INSPECTION STANDARD (HT LAB)

☐ Prototype		☐ Pre-Launch	☒ Production	Date (Original)	19.09.2022		
Part Name:- Ring Gear Z-77			Part No.:- CA139738	Inspection Standard Number	SIP/11000/190		
Customer :- CARRARO			Change Level.:- A	Part Stage	HT Lab.		
Sr.No.	Parameter	Special Char. Class	Methods				Reaction Plan
			Product Specification	Inspection Method	Inspection Frequency	Control Method

Space For Sketch:

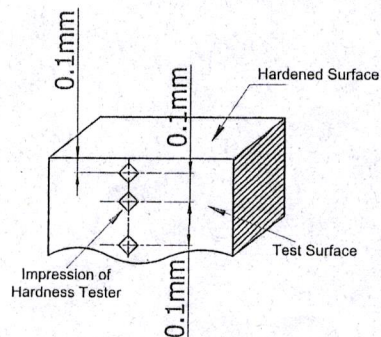
Date	Rev. No.	Change	Reason for Change	Date	Rev. No.	Change	Reason for Change
16/05/24	A	Revised Metallurgical Parameter Surface Hardness Change 58~62 Was 57~61 Core Hardness At PCD 45 HRC Max. Was 42 Max. Core Hardness At RCD 36 HRC Min. Was 31 Min. As Per ECN No. 30/24 On Date: 16/05/2024	Customer Change

1.	Surface Hardness	*	58~62 HRC Ⓐ	Rockwell Hardness Tester	1Pc/Lot	HT Lab Report	A
2.	ECD Measured At 544HV1 At PCD	*	0.7mm~1.1mm	Micro Vicker Hardness Tester/ Vicker Hardness Tester	1Pc/Lot	HT Lab Report	A

3.	Core Hardness At PCD	*	45 HRC Max. Ⓐ	Rockwell Hardness Tester	1Pc/Lot	HT Lab Report	A
4.	Core Hardness At RCD	*	36 HRC Min. Ⓐ	Rockwell Hardness Tester	1Pc/Lot	HT Lab Report	A
